MEMORANDUM

SUBJ: Review of Site 28 Five-Year Review

FIVE-YEAR REVIEW REPORT FOR IR SITES 26 AND 28
 NAS MOFFETT FIELD SUPERFUND SITE, MOUNTAIN VIEW, CALIFORNIA

X:\GIS_CAD_GINT\GIS\MapDocs\Five Year Review\Figure 2-8 Location of Existing Buildings, Vapor Intrusion Study.mxd

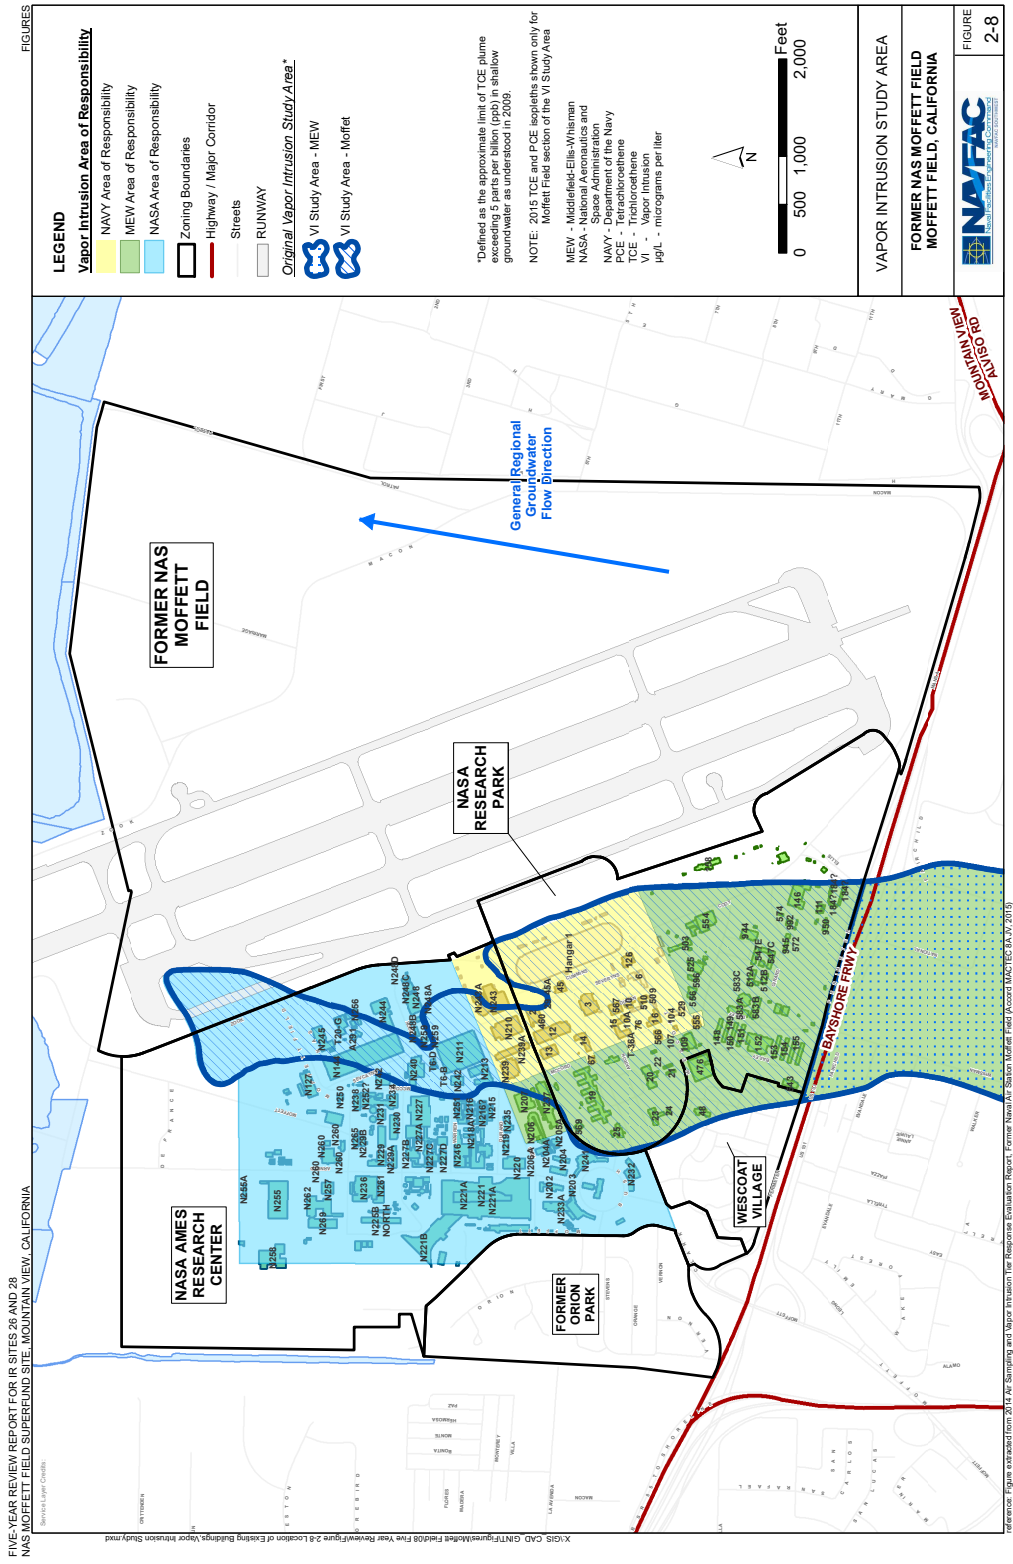
Based on air monitoring results through 2019, Buildings 3, 10, 45, 126, N239, and N239A have been Tier 1 or Tier 2, under the terms of the 2010 Vapor Intrusion Record of Decision (ROD). The Five-Year Review recommended the following vapor intrusion mitigation measures for these six buildings. (**See Below:** Tables 6A and 6B for Response Actions from the 2010 ROD.)

Building 3: Install sub-floor and sub-slab depressurization systems and conduct confirmation sampling.

Building 10: Remove the temporary vapor abatement system and asbestos-containing materials (ACM), construct a concrete wall, backfill with CLSM, remove the floor drain in Room 103, install a sub-slab depressurization system, and conduct confirmation sampling.

Building 45: Install a sub-slab depressurization system and conduct confirmation sampling.

Building 126: Install a sub-slab depressurization system and conduct confirmation sampling.

Building N239: Seal pathways and conduct confirmation sampling.

Building N239A: Seal pathways, install passive vents in the exterior walls of Rooms U101 and U102, and conduct confirmation sampling.
